100BASE-T1L PCS Receive Function

Philip Curran
Brian Murray
Jacob Riesco

► Text changes for section 190.3.4 PCS Receive function

Figure 190–13B—PCS Receive state diagram, part b

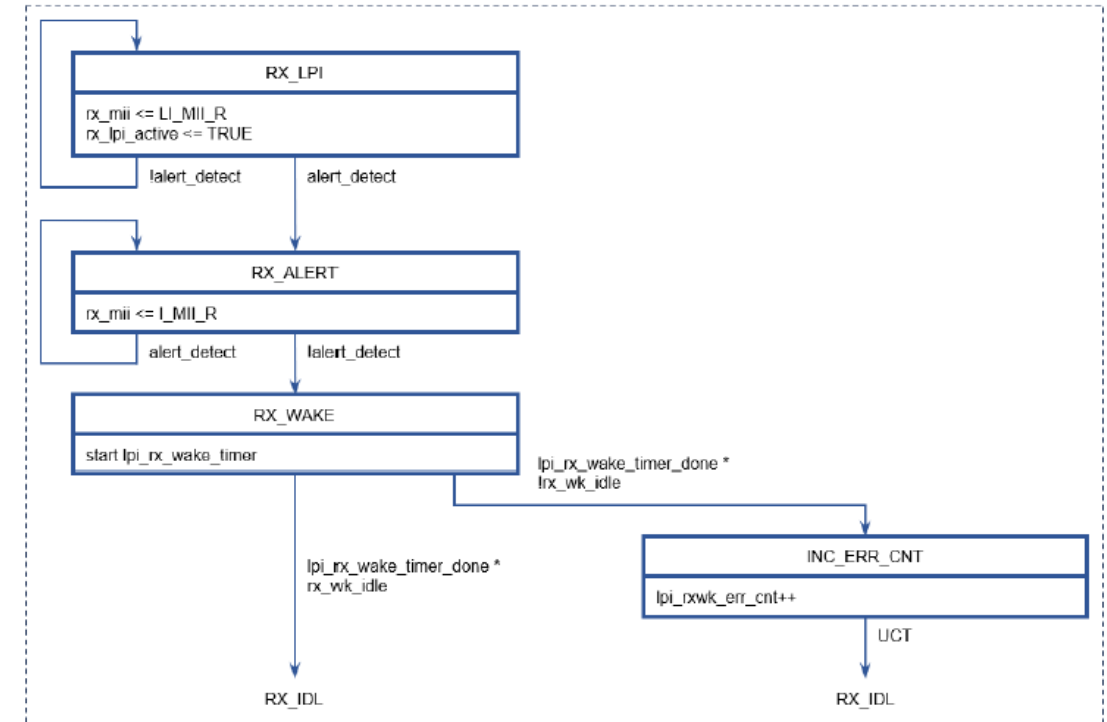
- In the RX_LPI state the PHY continuously signals **Assert LPI** at the MII receive pins
- When **alert_detect** become TRUE the state diagram transitions to RX_ALERT and **Normal inter-frame** is signaled at the MII

- Once wake signaling appears at the PMA to PCS interface **alert_detect** become FALSE and the state diagram transitions to RX_WAKE
 - The **lpi_rx_wake_timer** allows the wake signal to propagate through the PCS receive path
 - When RS-FEC is enabled the propagation delay is large
 - Once the **lpi_rx_wake_timer** expires the PCS receive function checks that the last 8 receive characters are all // control symbols, and if not, the wake error counter is incremented

Figure 190-13C—RFER monitor state diagram

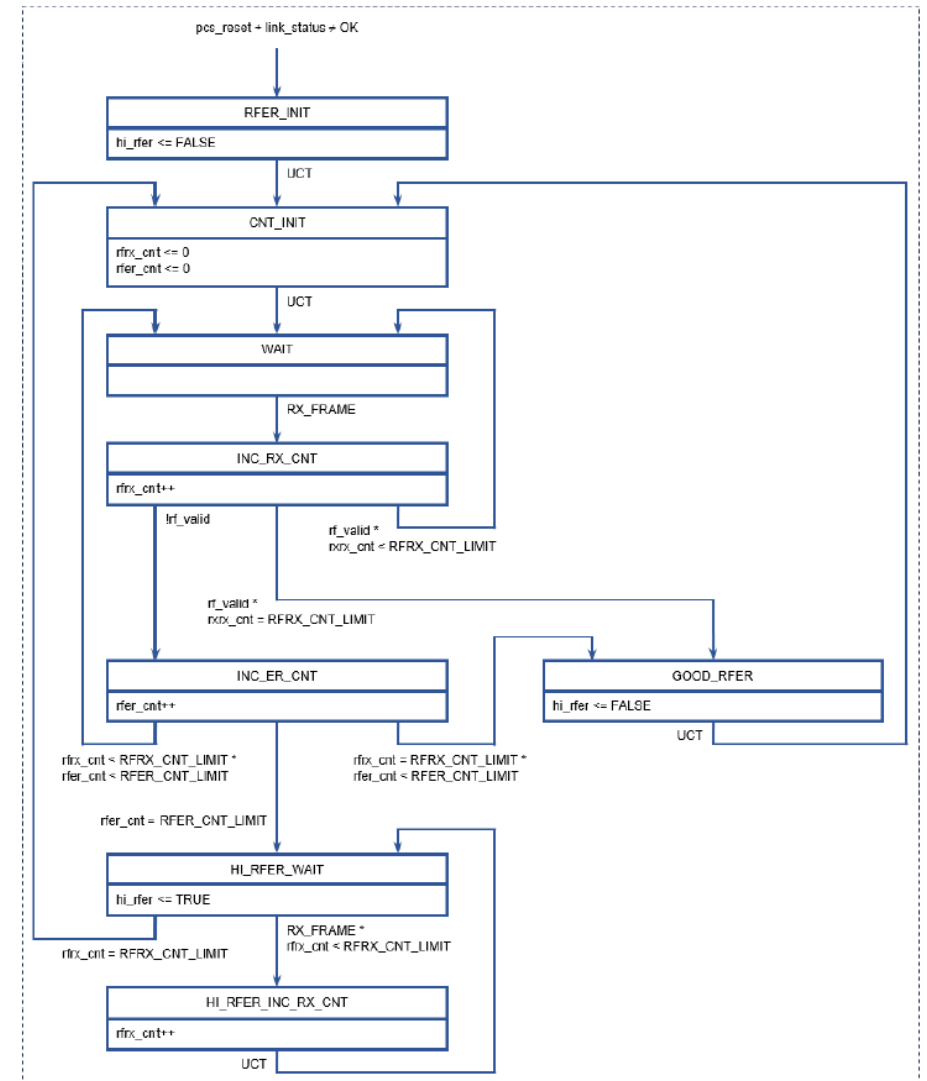
- ▶ PCS Receive function – RFER monitor
- ▶ This is based on clause 149 Figure 149-15 with some differences
 - RFER monitoring does not begin until the link is up
 - PHY control was designed to synchronize link establishment
 - We do not have a **block_lock** signal
 - Under conditions of high RFER the link drops and we restart Auto-Negotiation
 - In clause 149 the counters are reset when we enter receive LPI mode
 - We pause the counters but do not reset them

Figure 190–13B—PCS Receive state diagram, part a

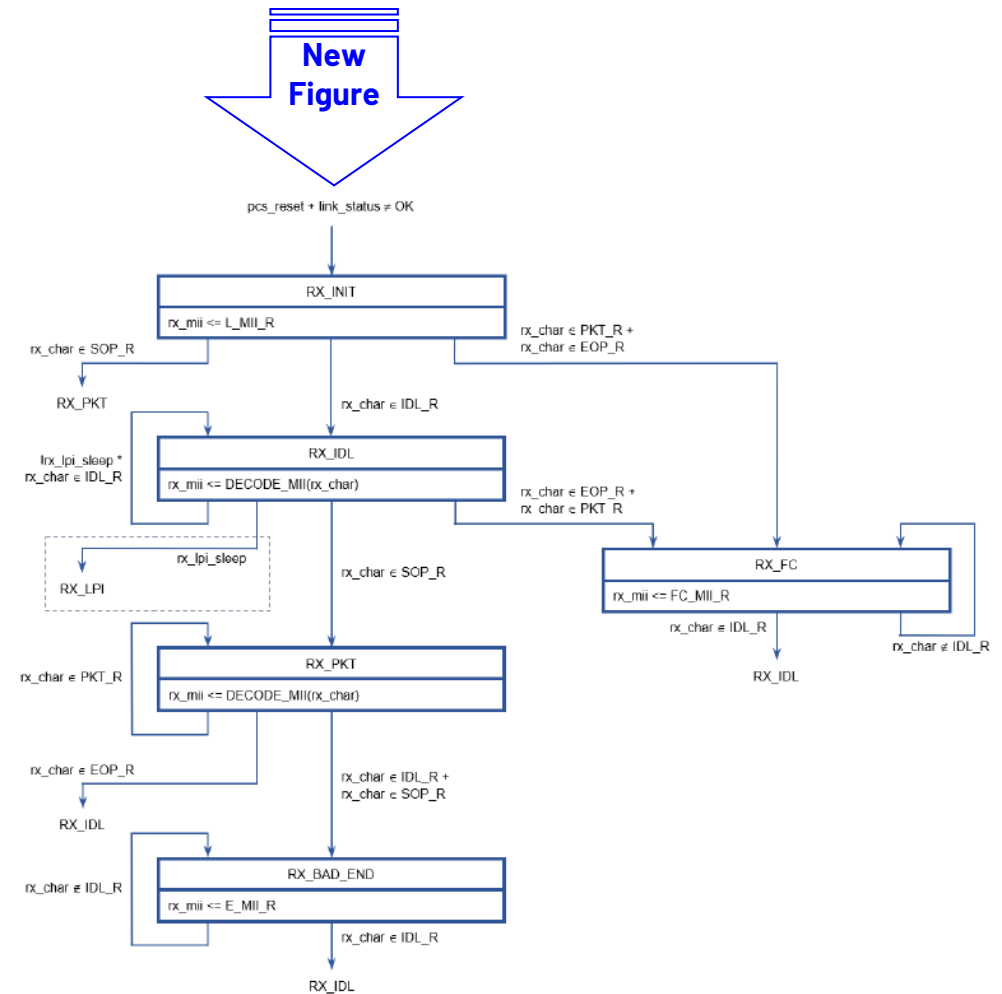
The PCS Receive state diagram shown in Figure 190–13B controls the conversion of received characters to signals at the MII. It evaluates the exit conditions for the current state exactly once for every 2 cycles of RX_CLK except for the INC_ERR_CNT UCT exit condition, which is evaluated immediately after the INC_ERR_CNT state actions are complete.

- New Figure 190–13B—PCS Receive state diagram, part a

Figure 190–13B—PCS Receive state diagram, part b

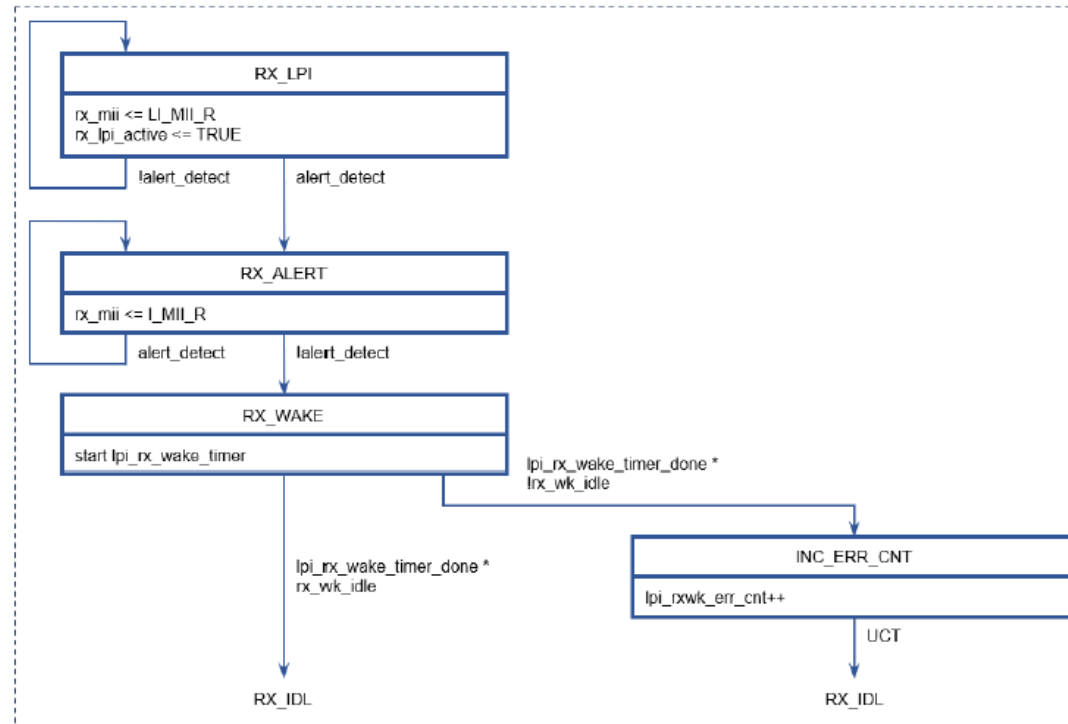
- ▶ Continue section 190.3.8.2 State diagrams
 - Continue State Diagrams for the PCS receive
 - New Figure 190–13B—PCS Receive state diagram, part b

Figure 190–13C—RFER monitor state diagram

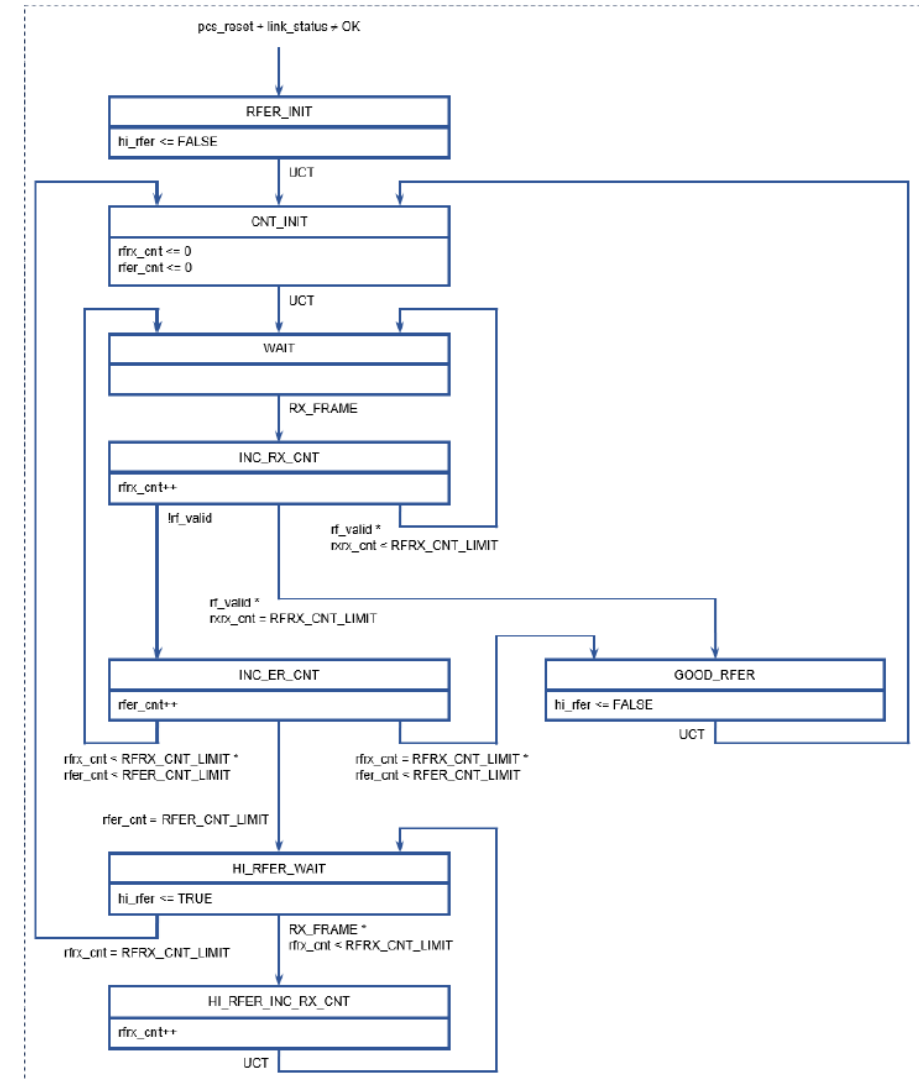
- ▶ Continue section 190.3.8.2 State diagrams
 - State Diagrams for the RFER monitor
 - New Figure 190–13C—RFER monitor state diagram
